***Harrington &
Gloucester Streets,
The Rocks:
Alterations to Mixed-
use Development***

State Significant
Development
Modification Assessment
(SSD 7037 MOD 2)

May 2019

Figure 7 | Proposed development photomontage showing roof looking south-east (Source: SSD 7037)

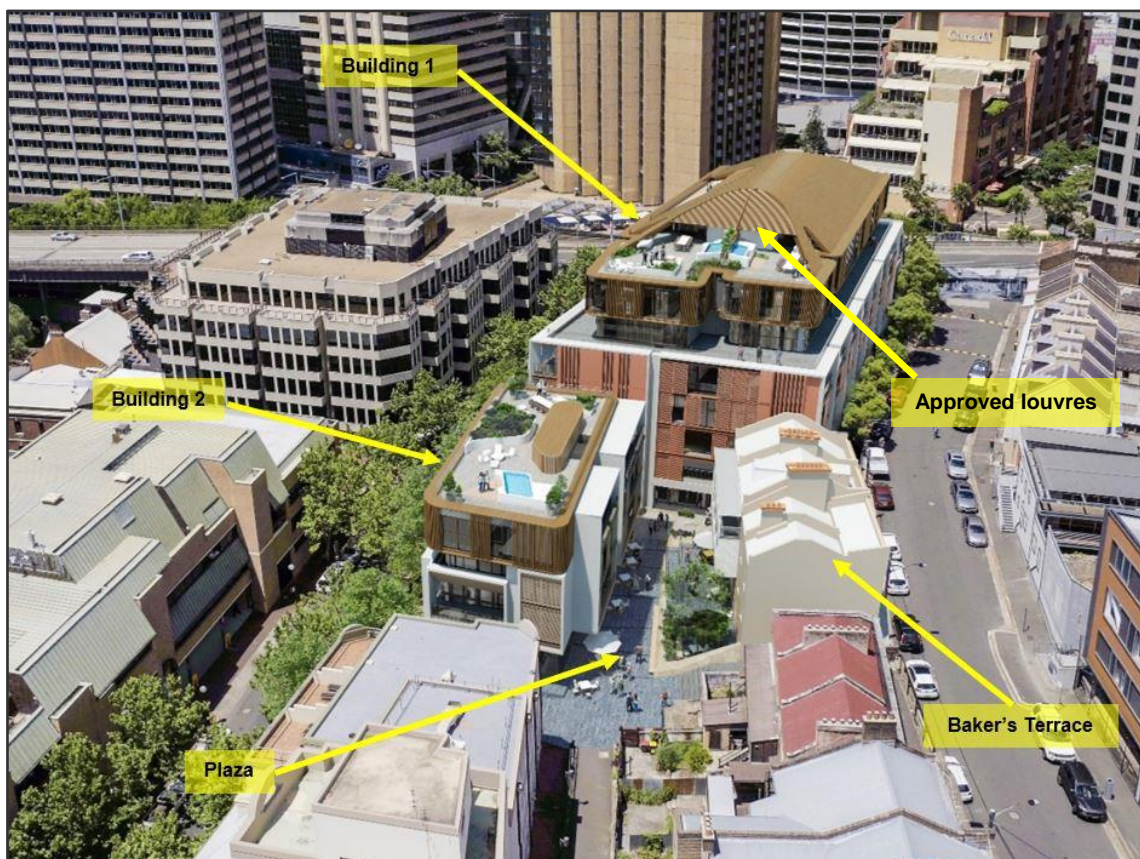
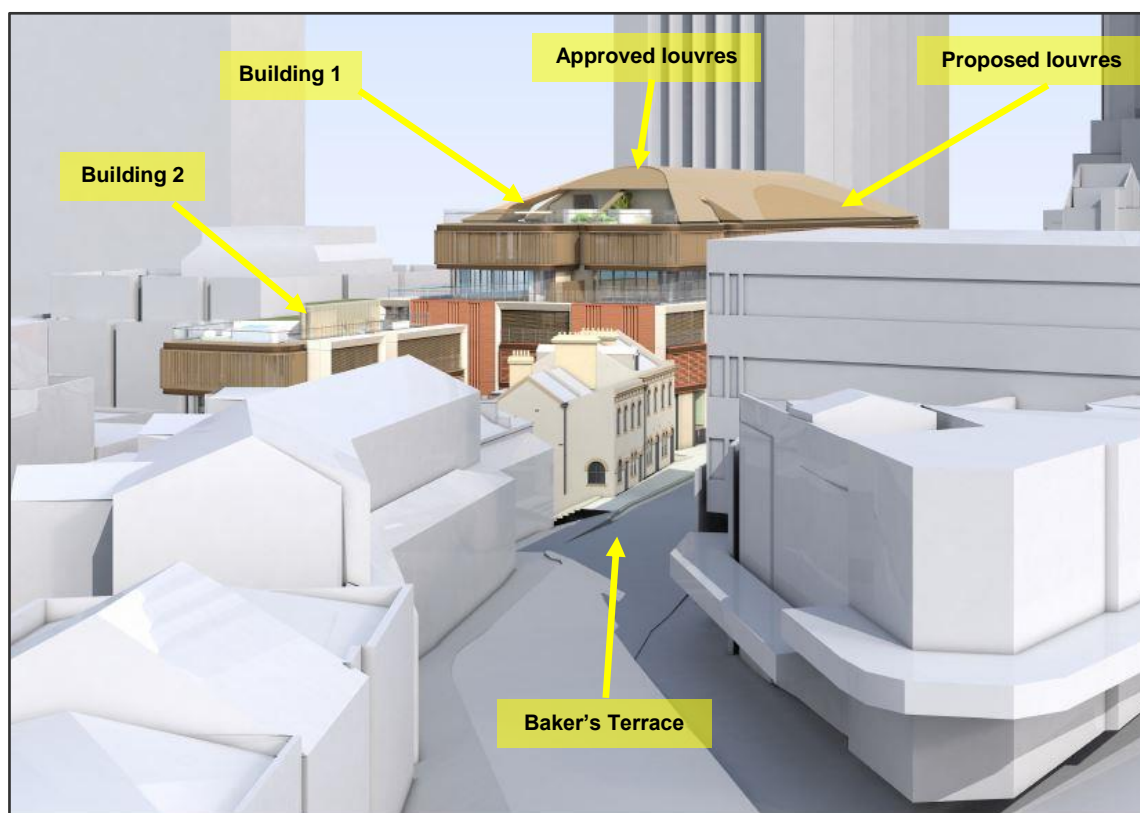
The Applicant proposes an additional louvred opening to the western side of the roof of Building 1 to provide ventilation for plant (see **Figures 6 and 7**). The portion of the roof proposed to be converted to louvres has an area of approximately 70 m².

- the materials and design of the louvres would be consistent with the existing louvres in the approved roof, including the use of bronze coloured/aged copper
- the proposed louvres would be consistent with the form of the roof and openings on the eastern and southern sides
- there would be minimal view into the plant from surrounding vantage points.

Figure 10 | Proposed Cambridge Place (Source: SSD 7037 RtS)

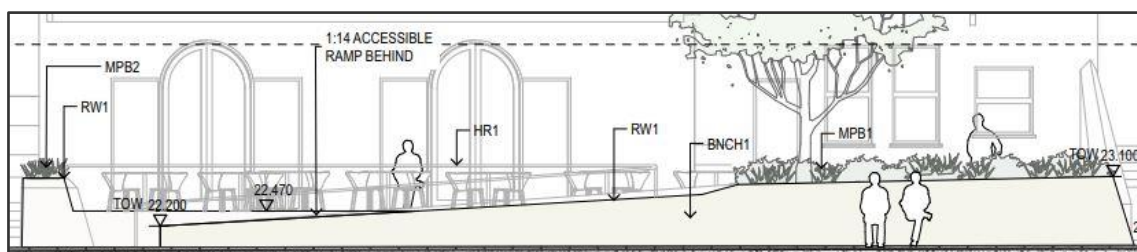
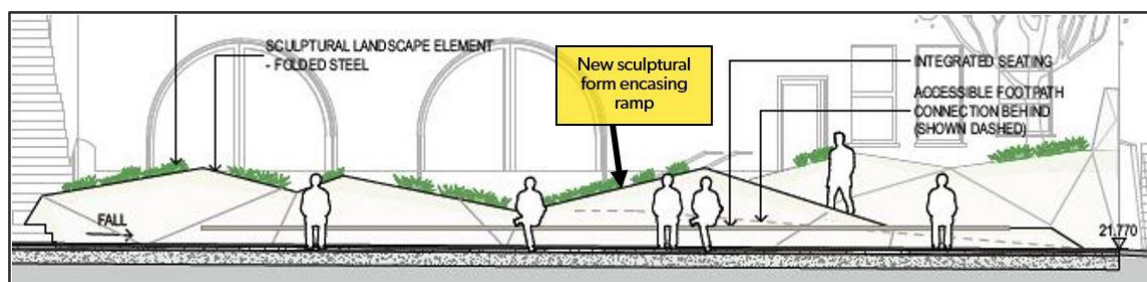
The Applicant proposes to provide a new sculptural form encasing the approved access ramp, and provision of interpretation areas and additional planting areas in the courtyard to the rear of the Baker's Terrace (see comparison with approved in **Figures 9** and **10**).

OEH Heritage supported the amendments and stated a condition should be included requiring submission of a Heritage Interpretation Plan. The Department agrees and recommends a new condition requiring the submission of a Heritage Interpretation Plan to the Planning Secretary for approval prior to the issue of a Construction Certificate.

- the retention of the Harrington Street stone wall is a positive conservation action
- they interpret the heritage of The Rocks in a contemporary way and would provide for greater consistency with the surrounding public domain and heritage interpretation
- they would enhance the positive benefits of the approved public domain works
- they would not block views to the Baker's Terraces, impact on significant values or other fabric.
